Proposal Request

PROJECT: *(name and address)*
AWSOM
Bentonville, Arkansas

PROPOSAL REQUEST 039

MSE Walls, Curbs, and Grading

1 Materials Plan - Ground Floor 2
Scale: 1/16" = 1'-0"

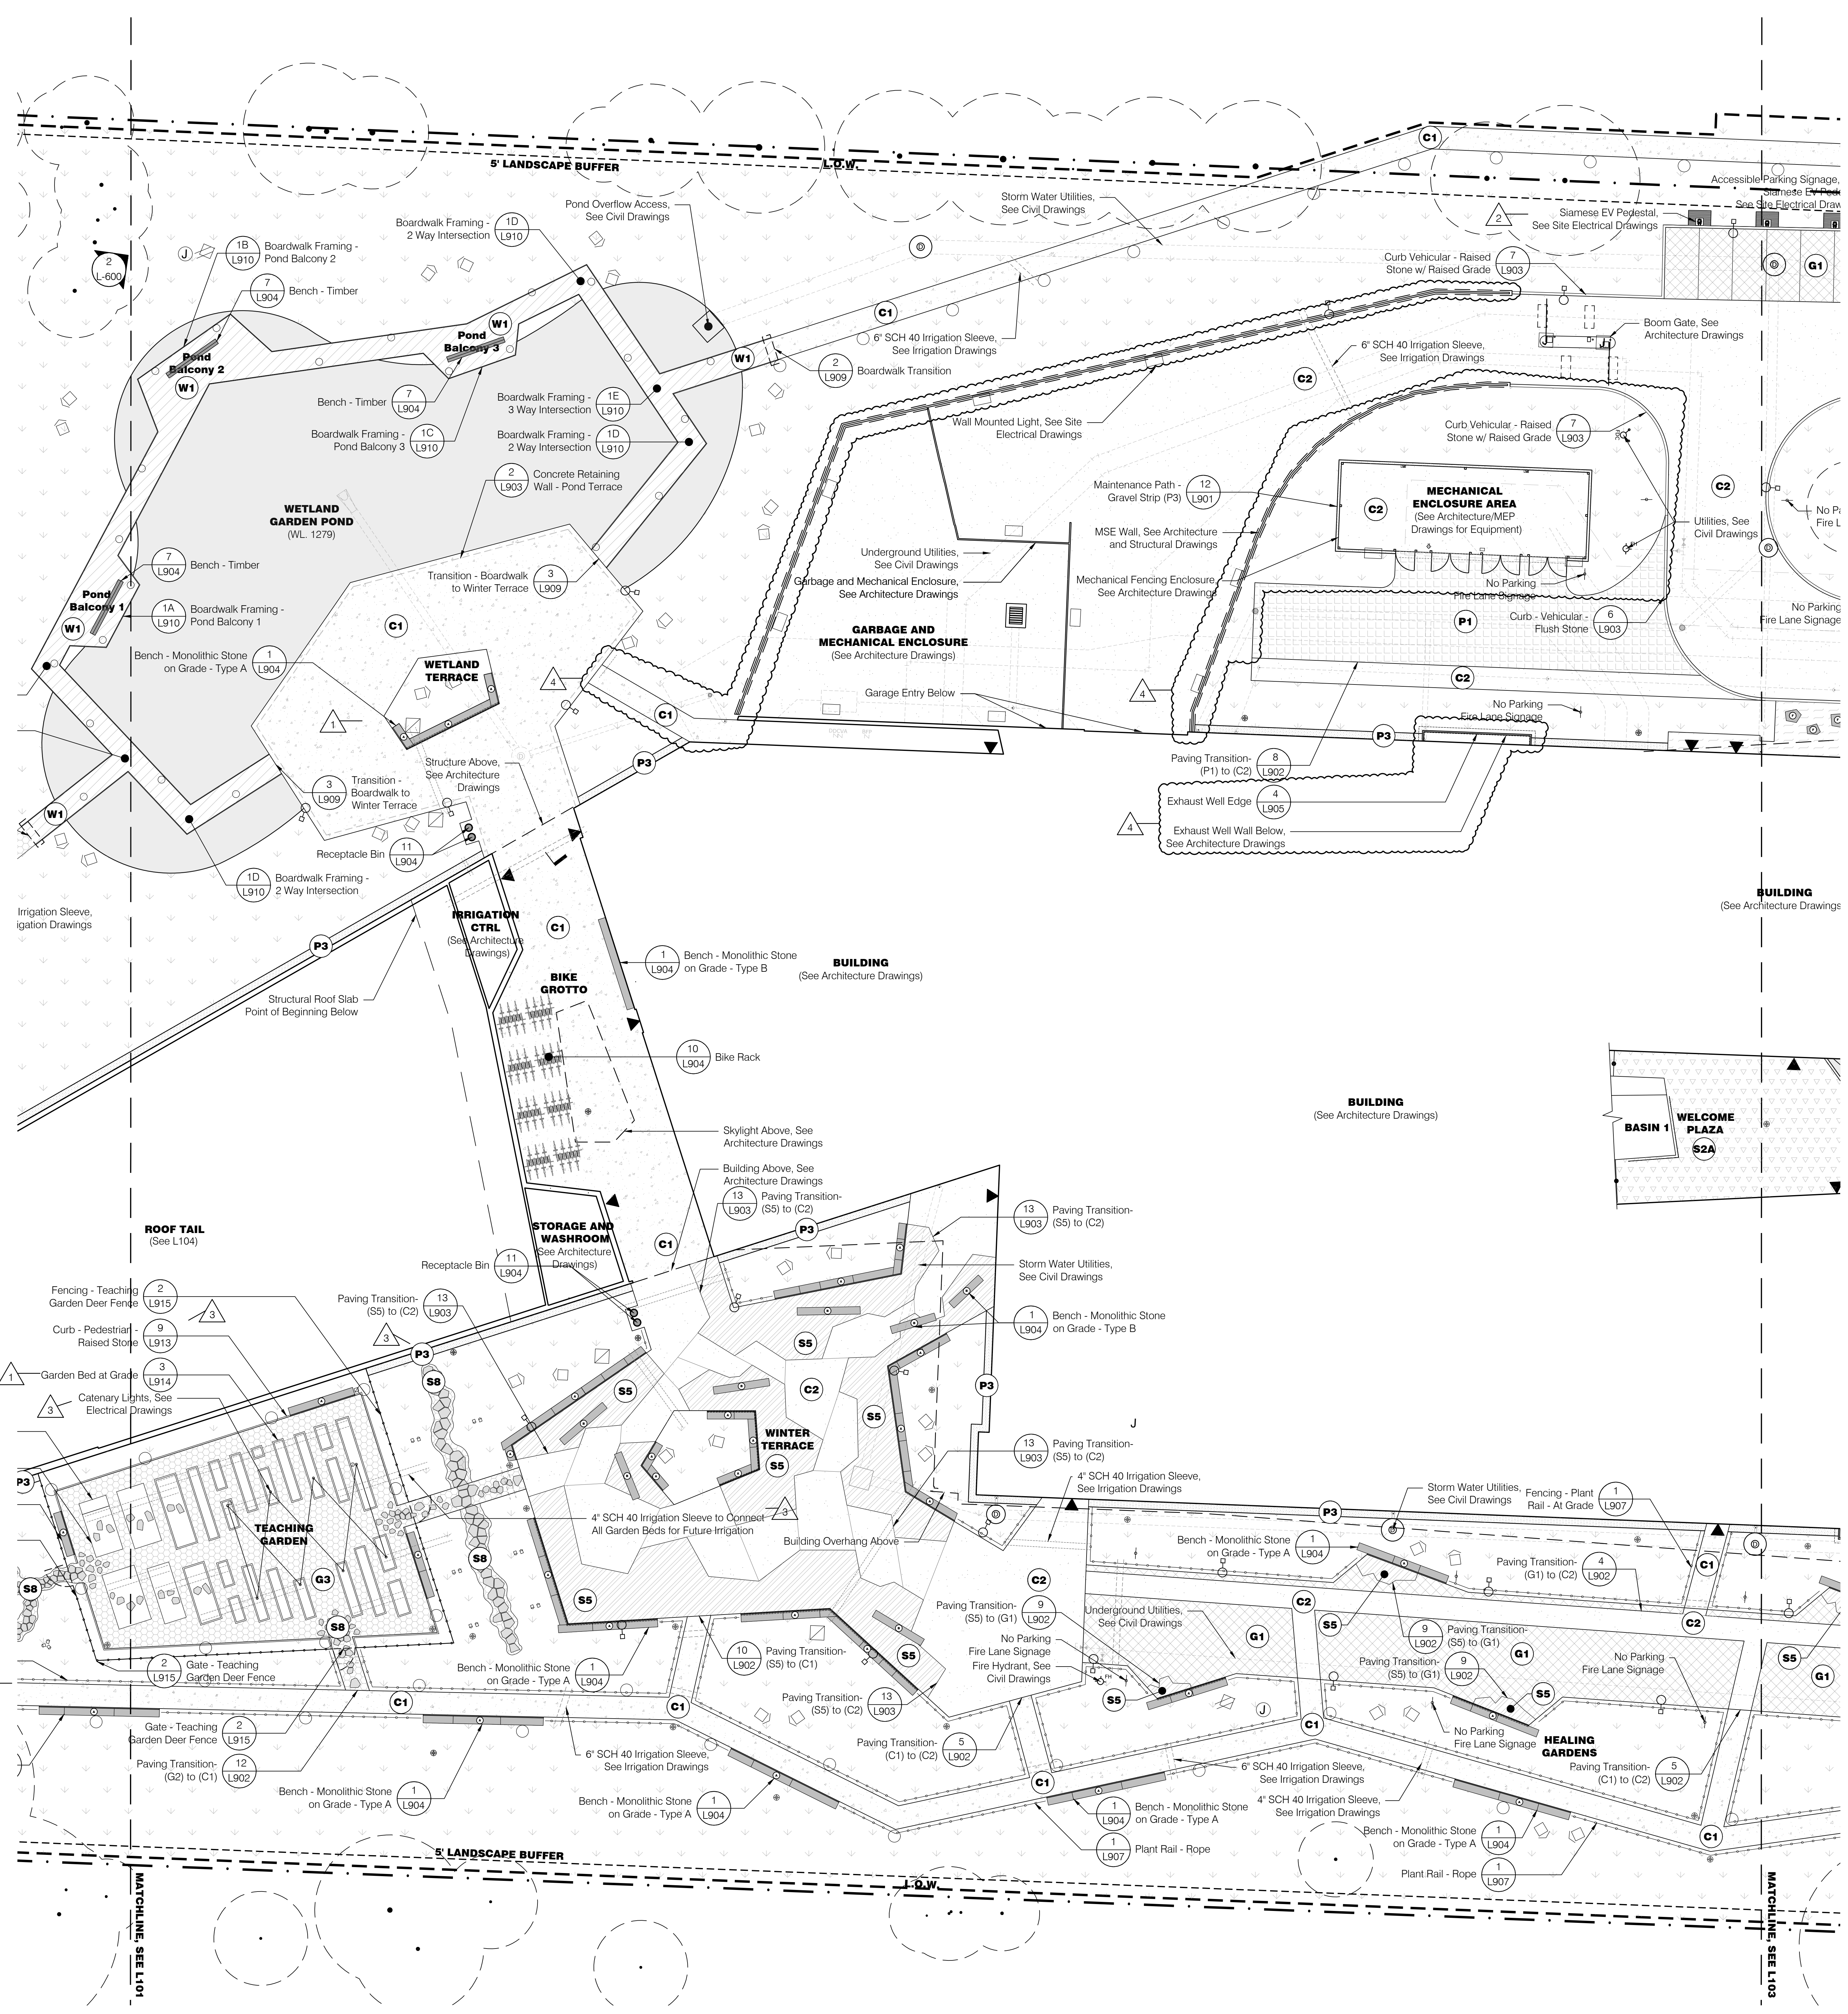
- a) Refer to Revised Sheet **L102**, with original issue date 03.13.2023 and revision date 04.04.2024.
 - Updated path connection to wetland terrace
 - Curbs removed from P1 extents south of mechanical enclosure area.

- MSE wall geometry updated per PSW updates.
 - Architectural exhaust well added on north side of architecture.
 - Updates notes and detail call outs at exhaust well.

- P3 maintenance strip added along mechanical enclosure pad.
- b) Refer to Revised Sheet **L103**, with original issue date 03.13.2023 and revision date 04.04.2024.

1 Materials Plan - Ground Floor 3
Scale: 1/16" = 1'-0"

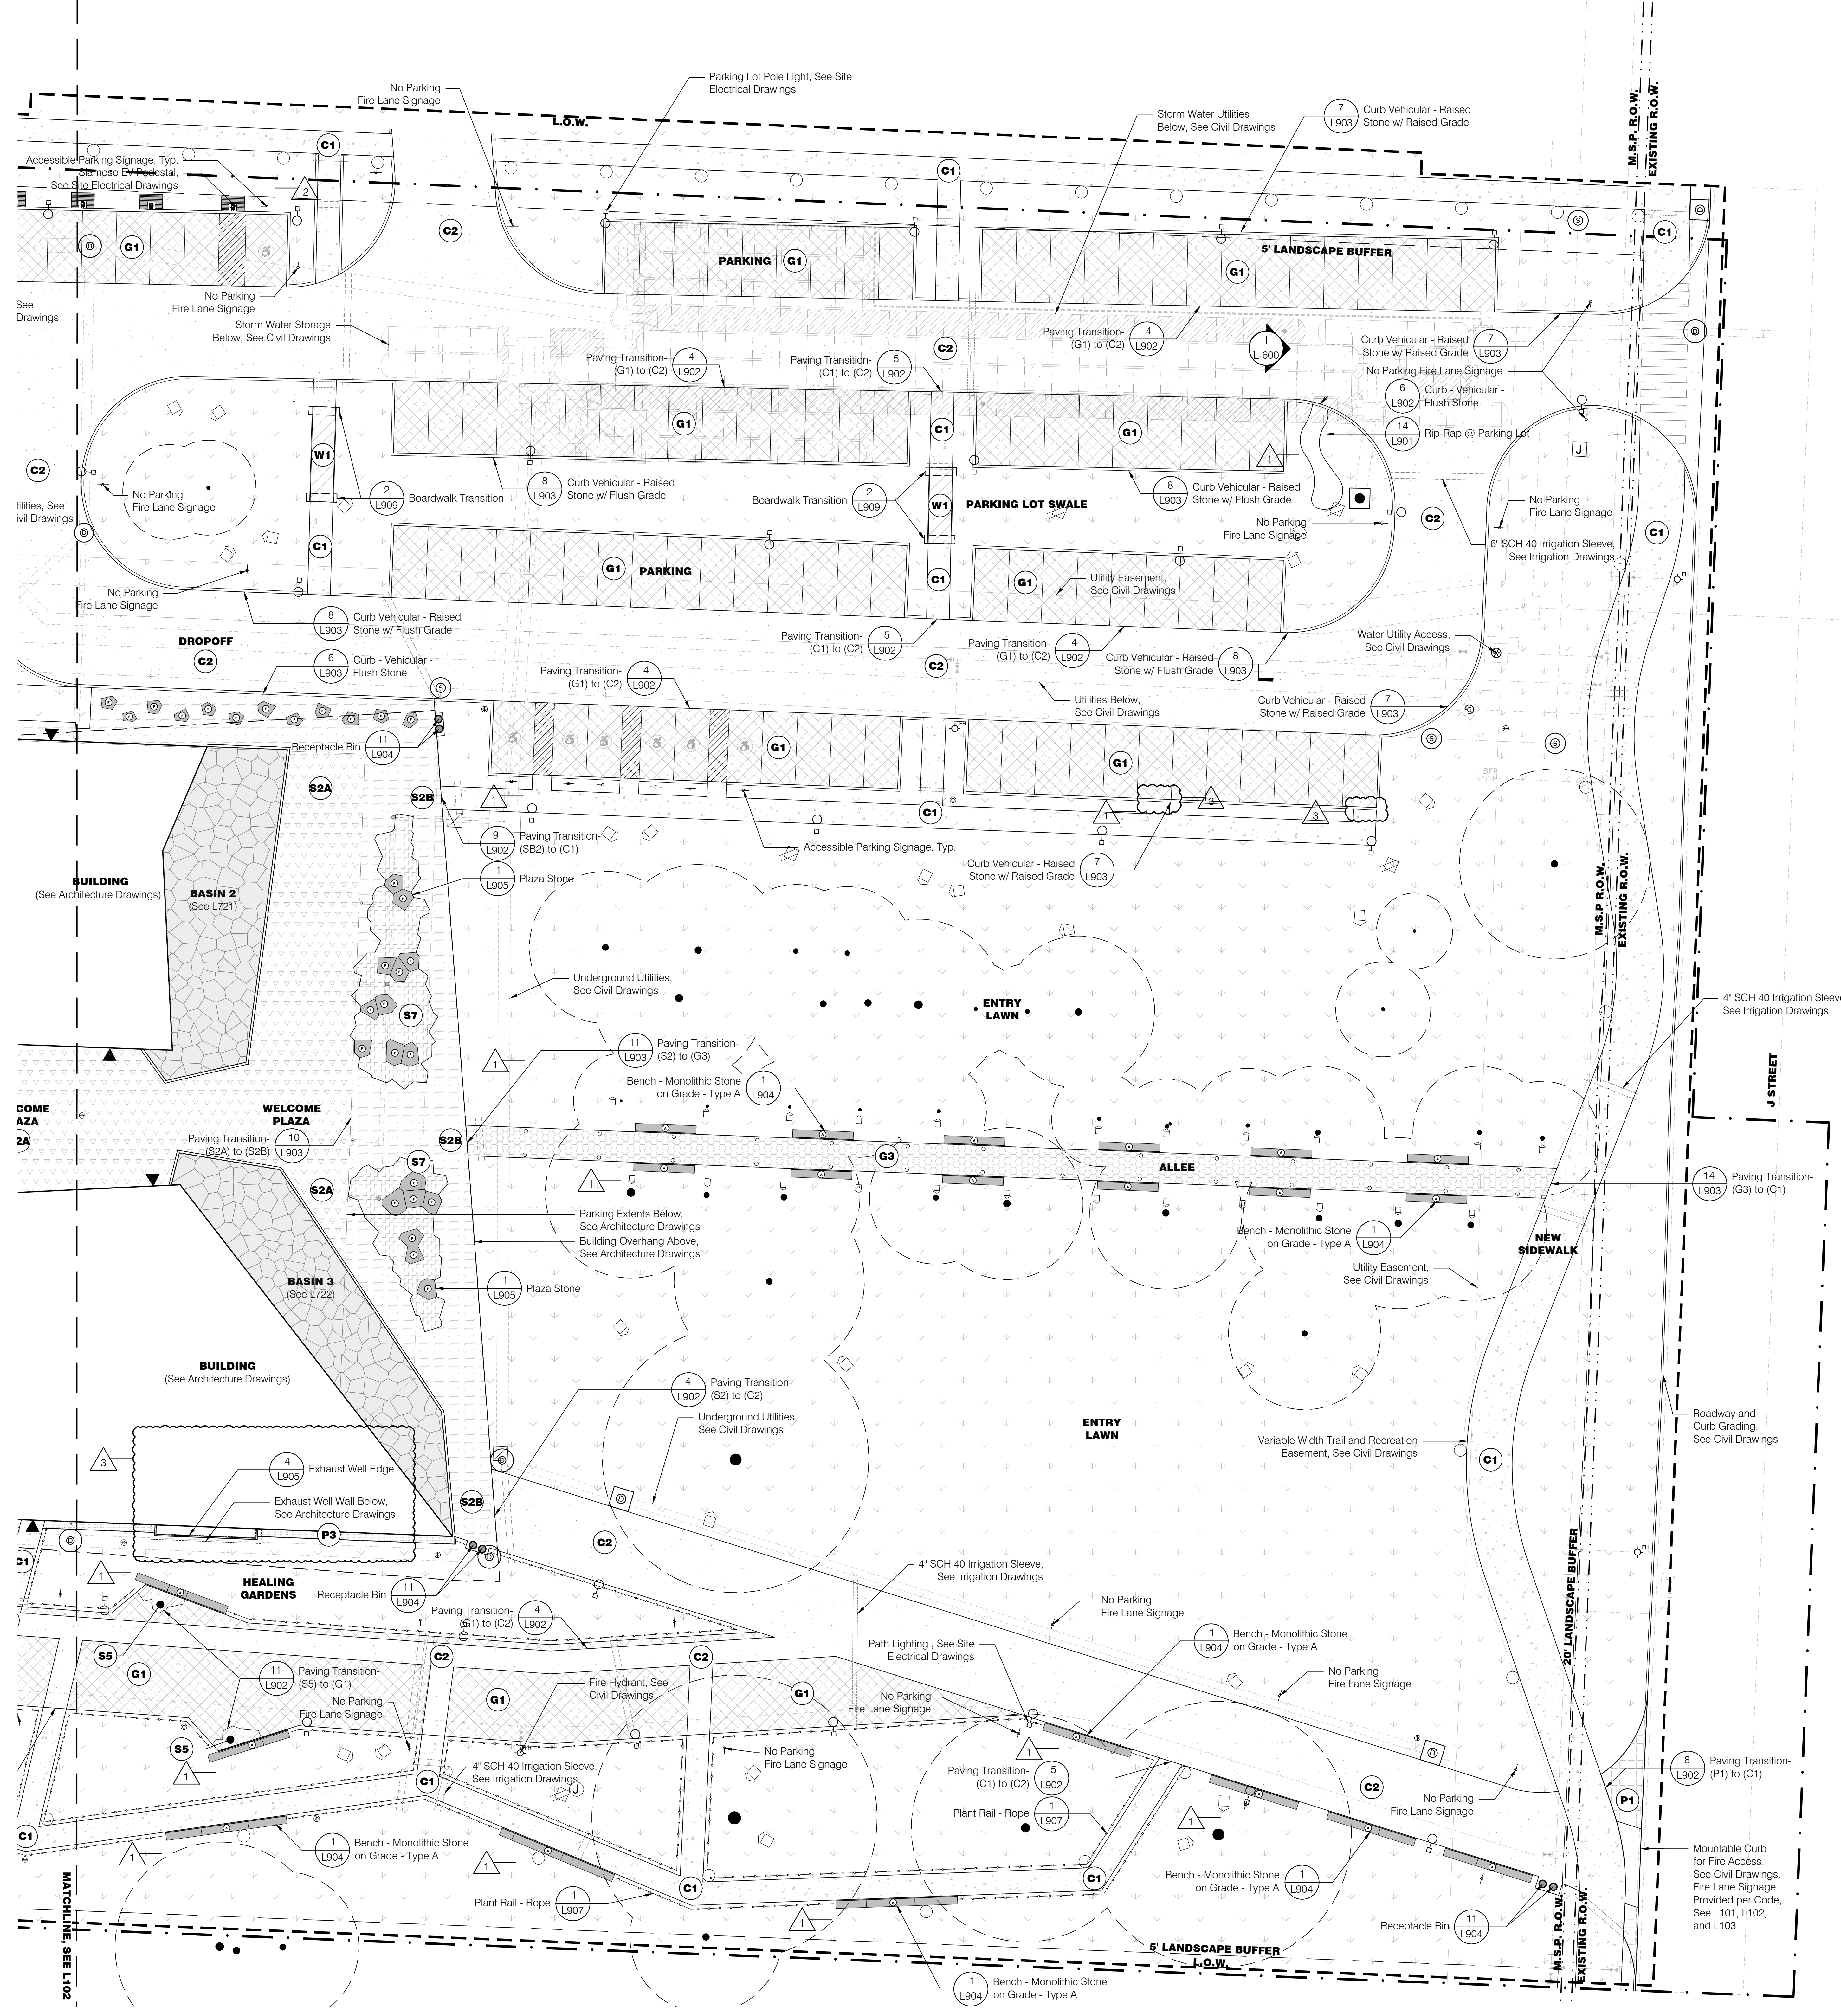
- Architectural exhaust well added on south side of architecture.
 - Updates notes and detail call outs at exhaust well.
 - Curbs extended in southeast parking bay.

1 Layout - Hardscape - Ground Floor 2
Scale: 1/16" = 1'-0"

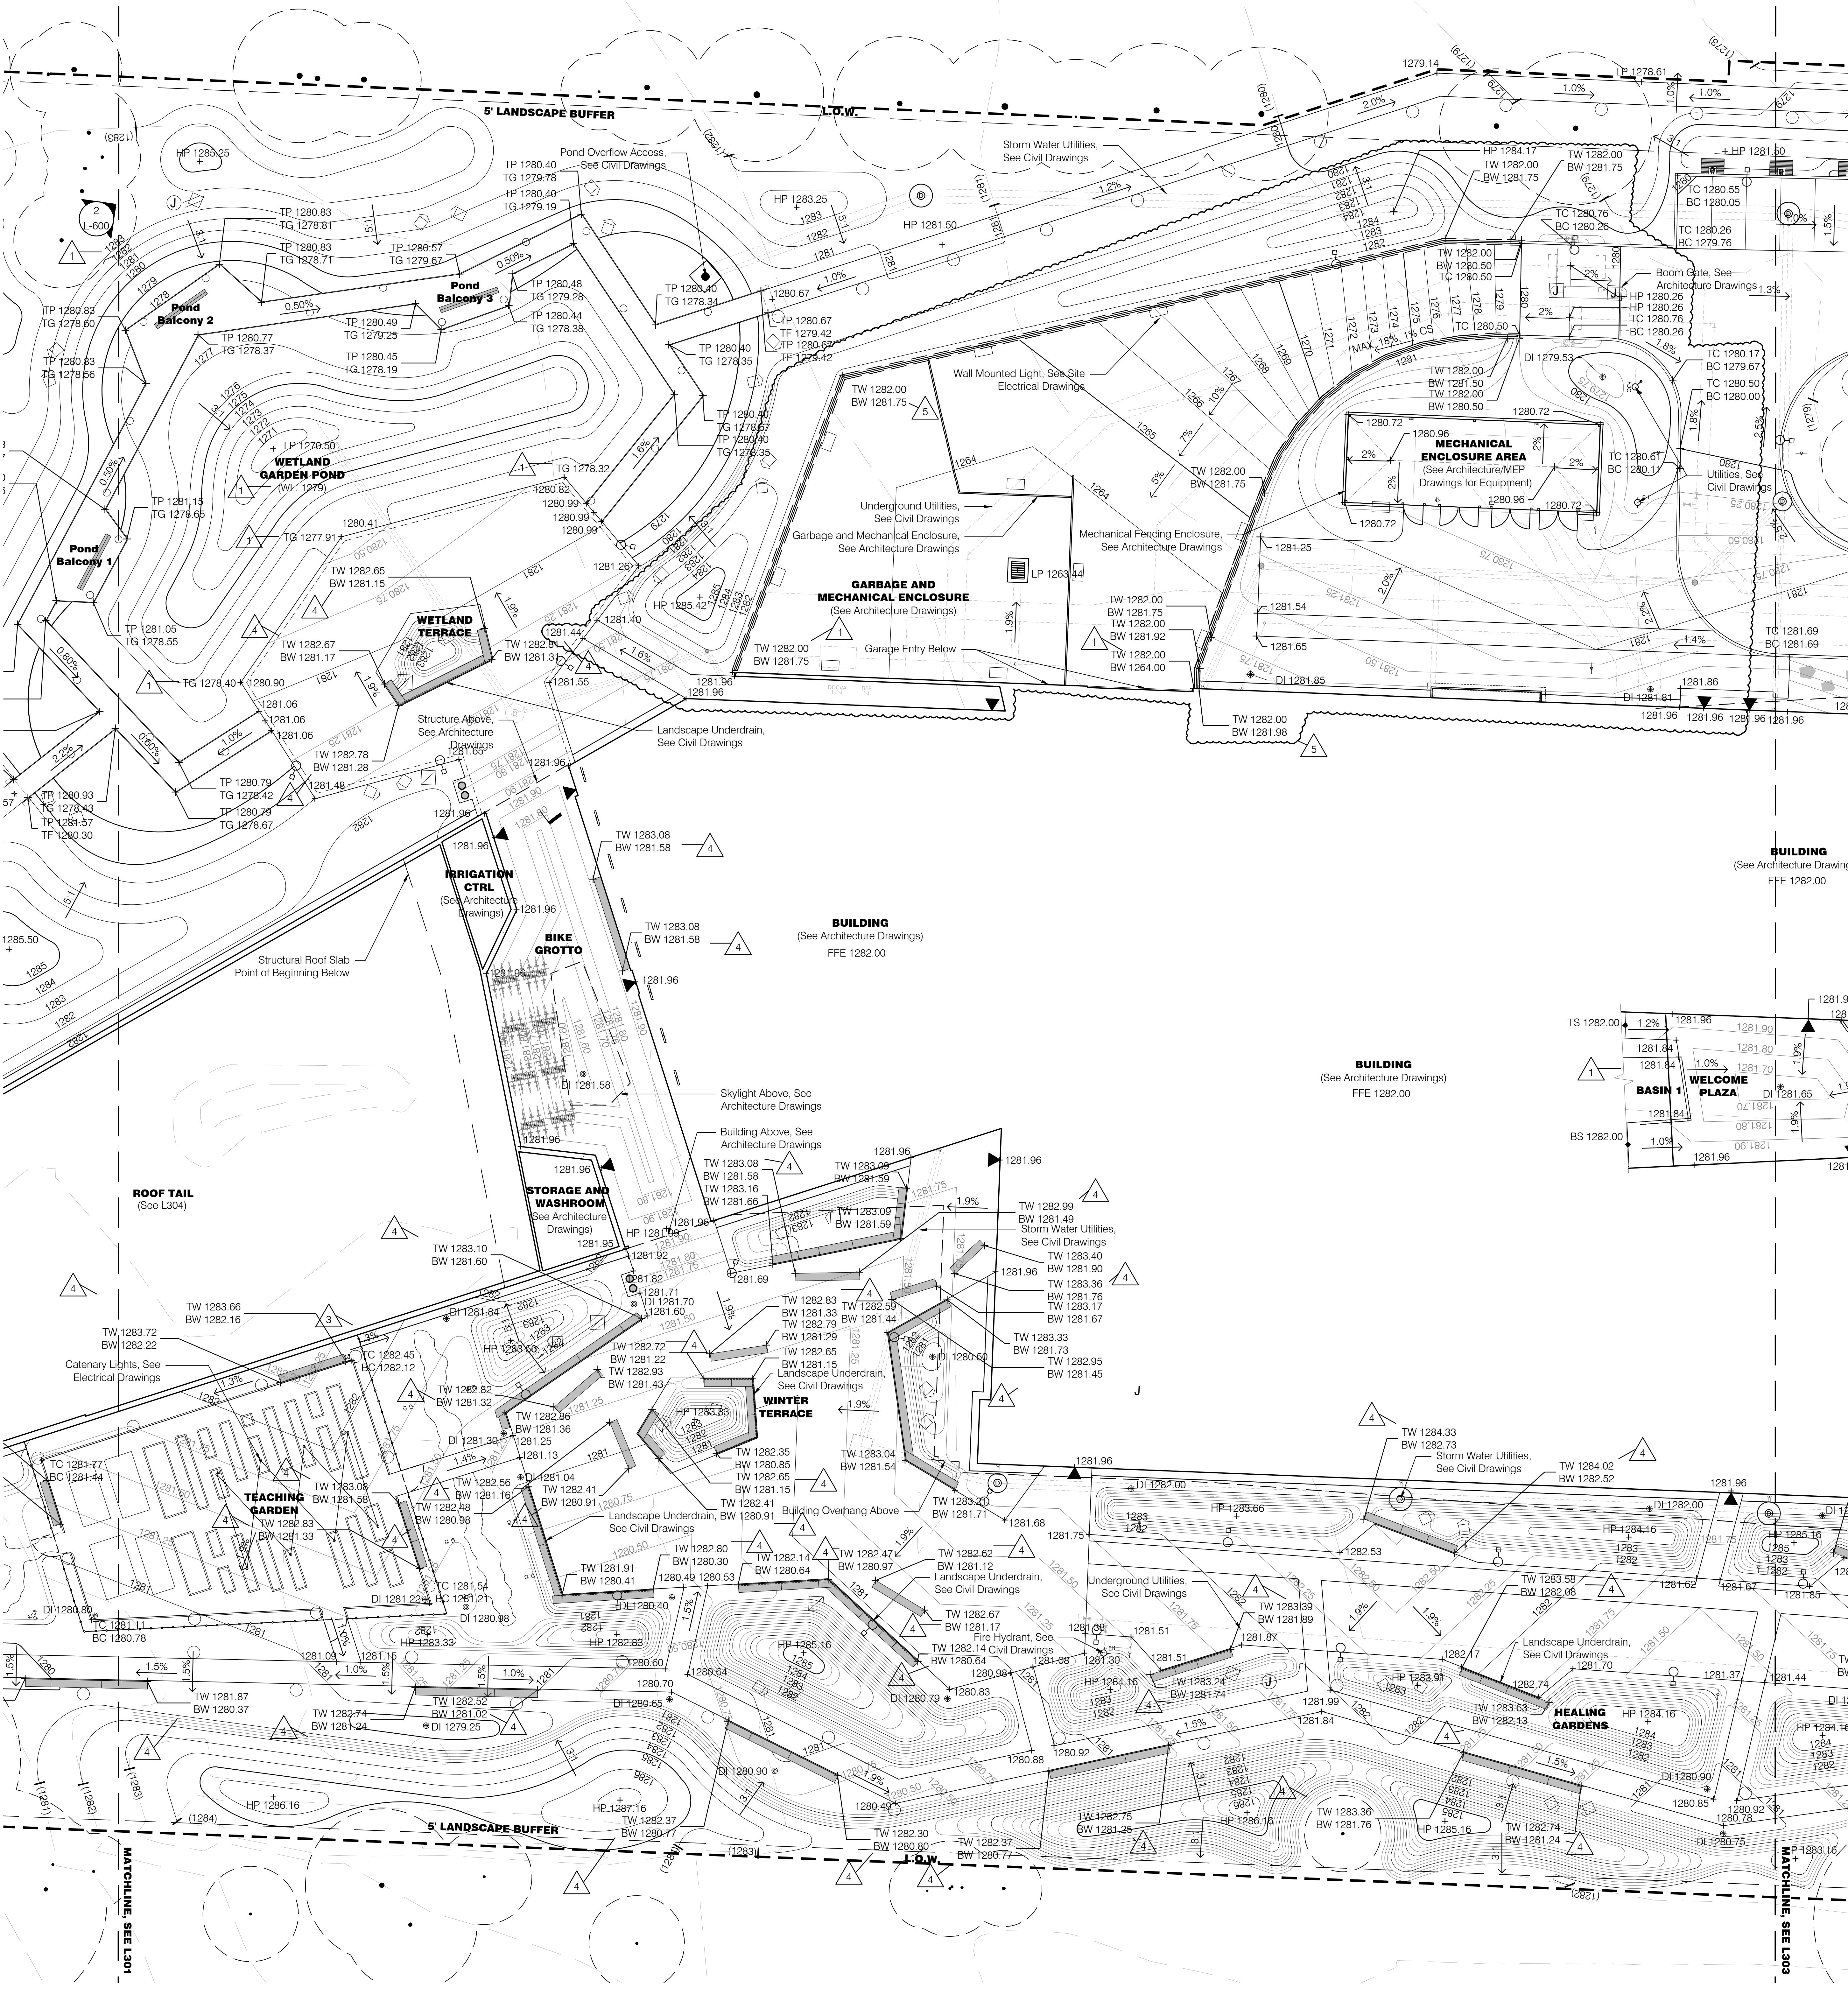
- d) Refer to Revised Sheet **L202**, with original issue date 03.13.2023 and revision date 04.04.2024.
 - Updated coordinate points at path to wetland terrace.

- Updated layout note on MSE walls.
 - Coordinates removed from MSE walls, refer to Architectural drawings for layout info.
 - Curb spots removed at fire lane turn around south of mechanical enclosure.
